UNITED STATES PATENT AND TRADEMARK OFFICE

APPLICATION NO.	FILING DATE	FIRST NAMED INVENTOR	ATTORNEY DOCKET NO.	CONFIRMATION NO.
10/656,027	09/04/2003	Barry Byron	33535/US	8490

Office Action Summary

DETAILED ACTION

FIG.11

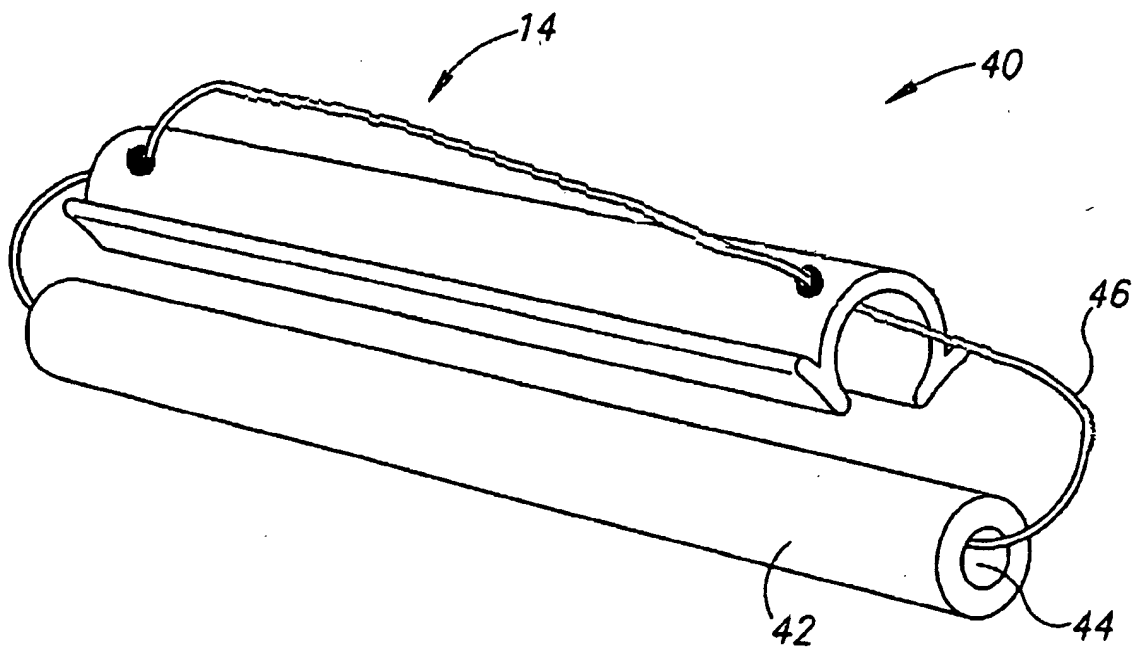
1. The disclosure is objected to because of the following informalities: There is no mention of Figure No. 11 in "Brief Description Of The Drawings" as well as in the "Detail Description of the Invention".

Newly submitted Figure No. 11 has been approved.
